<p>REVIEWERS: John Harvey, Joep Meijer (chair) and Christoph Koffler</p> <p>PCR Review Panel comments on the draft Product Category Rules (PCR) for Preparing an Environmental Product Declaration for: Asphalt Mixtures are divided into the following categories:</p> <ol style="list-style-type: none"> 1. Technical comments; 2. General comments; and 3. Editorial comments. <p>NOTE: With the exception of items noted in the matrix below, the Critical Review Panel is satisfied that other standard requirements (e.g., ISO standards) have been satisfactorily met.</p> <p>1. Technical comments</p>	
---	--

Date: February 6, 2017

Project: NAPA PCR

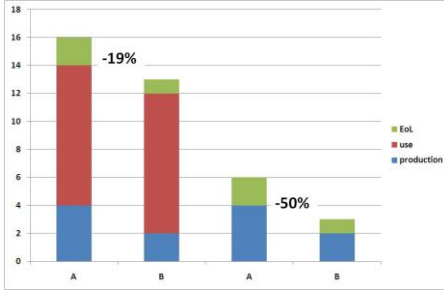
T24	13	11.a	<p>The argument given in the text box is flawed, but unfortunately very common in LCA to this very day. It is not sufficient to argue that everything that is the same between product systems can be excluded from the system boundary because it won't affect the conclusions. While the absolute difference between product systems and the direction of the decision will not be affected, the percent difference will be artificially inflated if the excluded activities would have a significant contribution to the overall result. See below chart for a simple example where the same absolute result leads to vastly different percentage differences by excluding an identical use phase.</p>

Scenario	System	Production (Blue)	Use (Red)	Eol. (Green)	Total	Production	A	4	0	0	4	B	2	0	0	2	Use	A	4	2	0	6	B	2	1	0	3	<p>If anything, the argument should be that something is (a) the same for both and (b) not expected to have a relevant contribution to ANY of the considered impact categories (which is quite the audacious assumption).</p> <p>However, in that case you can exclude these things based on relevance alone, so the whole argument about things being the same between product systems is highly questionable in my eyes. It is just something that people hear other people say and they believe it. It's an urban legend of LCA, if you will.</p> <p>Based on the same argument given in the text box about using "similar capital goods to produce the same product", you could then also exclude the raw materials since all asphalt mixture producers use "similar raw materials to produce the same product".</p> <p>Not sure the point was fully understood so I will try one more time. By excluding parts of the product system based on "similarity", you are artificially increasing any percentage differences between asphalt mixtures EPDs that may be calculated by the audience. So the question becomes whether this bias, because that's what it is, is significant or insignificant, which in turn depends on whether the excluded burdens are significant or not compared to what is not excluded.</p> <p>So the exclusion needs to happen based on significance and not based</p>	<p>Point understood, however the point of this EPD program is for asphalt mix producers to communicate the environmental performance of asphalt mixtures to agency engineers and architects who have control over specifying various asphalt mixture requirements in line with accepted LCA practices. That being said, capturing the differences among the environmental footprints of asphalt mixtures is the focus of this program. Any differences in production equipment are captured and recorded in the collection of energy-use data and production data, making evident the impact of those differences in the capital goods.</p> <p>RW: The reviewer's argument is that when the equal and common components between two options (A and B) are discounted, the relative difference in "artificially inflated".</p> <p>The above example is appropriate for discussing the exclusion of factors - such as capital goods - that would be equal and common to two mixtures A and B coming from the same plant. If a choice is made between A and B the exclusion of the red bar would not change the direction of the decision, but would definitely place mixture B at a greater disadvantage. While the reviewer considers this "inflation" problematic, this EPD program finds this desirable. The exclusion helps emphasize the difference between the mixtures, allowing decisions-makers to focus on the green bars that are directly within the control of designers, decision-makers and plant managers. The more pertinent argument is that by adding uncertain and</p>	Yes
Scenario	System	Production (Blue)	Use (Red)	Eol. (Green)	Total																													
Production	A	4	0	0	4																													
	B	2	0	0	2																													
Use	A	4	2	0	6																													
	B	2	1	0	3

<p>on “similarity” in order to avoid the above potential bias. The current language leaves it open whether or not you just introduced a relevant bias to the comparison of EPD results by the audience.</p> <p>Why does it matter? Because two mixtures may appear to be 20% different in GWP when, in fact, they would only be 2% different if you hadn’t excluded things based on similarity. This is not to be taken lightly as it may influence purchasing decision based on incomplete data. I maintain that based on the similarity argument alone, you could also exclude the main raw materials from consideration, which of course wouldn’t make any sense.</p>	<p>unverifiable impacts from manufacturing capital goods that are common to both mixtures, and cannot be directly controlled to reduce the impact of the decision-processes, the difference in impacts is being diluted. We believe it to be preferable to avoid dilution of critical differences that can be acted upon (e.g., increasing plant efficiency, or improving mix designs) rather than adding aspects (e.g., capital goods) that cannot be acted upon.</p> <p>RW2: The textbox has been removed.</p>
